Product Change Notification

December, 2008

Bourns® Trimpot® Product Line Announces TC33B Product Change

Current versus New TC33B

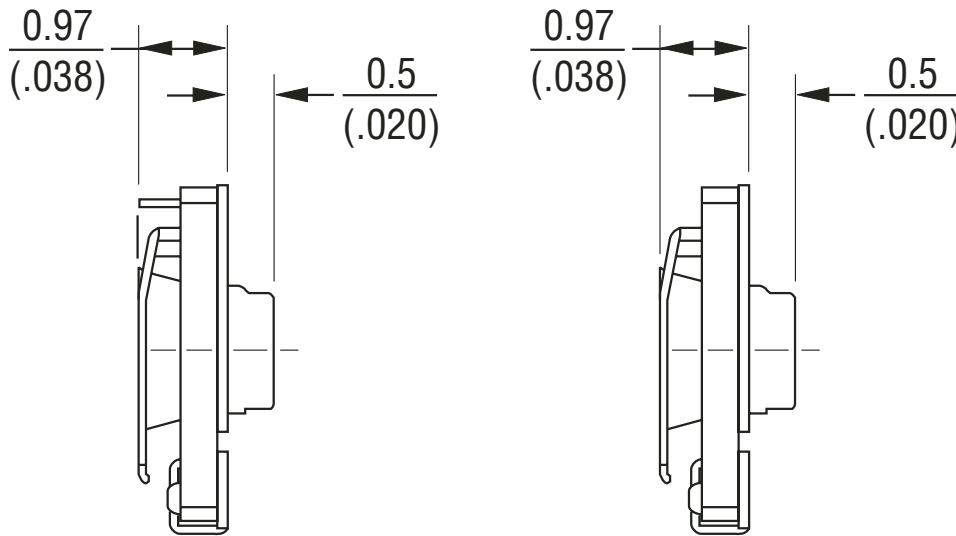
Bourns is pleased to announce a product change on [Model TC33B](#). The current TC33B has a mechanical stop. The mechanical stop is being removed for ease in adjustment. There is no change in the electrical, mechanical or environmental specifications of this model.

The new version will begin shipping on March 30, 2009. There will be a transition period where both versions will be shipped.
